AEP:NRC:7055-07

Donald C. Cook Nuclear Plant Units 1 and 2
STEAM GENERATOR TUBE INSPECTION REPORT
REQUEST FOR ADDITIONAL INFORMATION

STEAM GENERATOR TUBE INSPECTION REPORT
REQUEST FOR ADDITIONAL INFORMATION

DC Cook Unit 1 SG 13 - Bobbin Coil Inspection

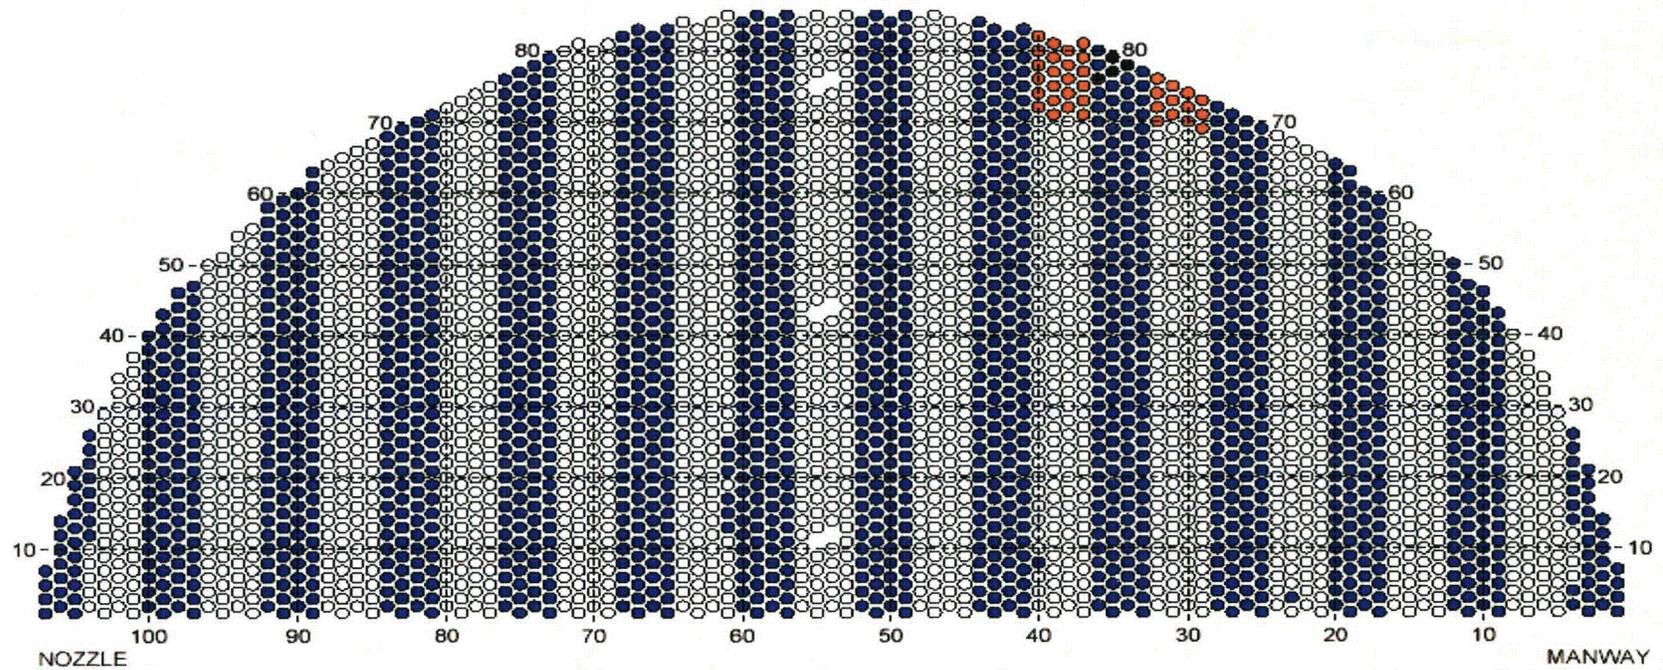
Please discuss whether the wear indications in the tubes in row 69 column 29 (R69C29), R69C27, and R68C28 were detected with the bobbin coil. Please discuss whether the possible loose part (PLP) indications in R84C60 and R85C61 were identified with the bobbin coil. Please clarify which five tubes had PLP indications in SG 13. If the above indications were not detected with the bobbin coil, please discuss the basis for the rotating probe inspection scope at the top of the tubesheet. In this response, discuss the scope and results of any secondary side inspections (including foreign object search and retrieval).

During the U1C21 inspection, the base bobbin coil examination (blue pattern on Enclosure 1) detected indications of loose part wear affecting four tubes in the cold leg region of SG 13 within an inch of the top of the tubesheet. The four tubes involved were R79C35, R78C34, R77C35, and R76C36 (4 black tubes on Enclosure 1). There was no detection of a foreign object around these tubes from the eddy current examination. When the wear was first detected, the cold leg was not available for rotating coil eddy current examination. Since the bobbin coil had detected the indications, the examination was expanded (orange tubes) to fully bound the region with the

bobbin coil. This expansion detected a PLP indication in tube R69C29 at the top of the cold leg tubesheet and no additional indications.
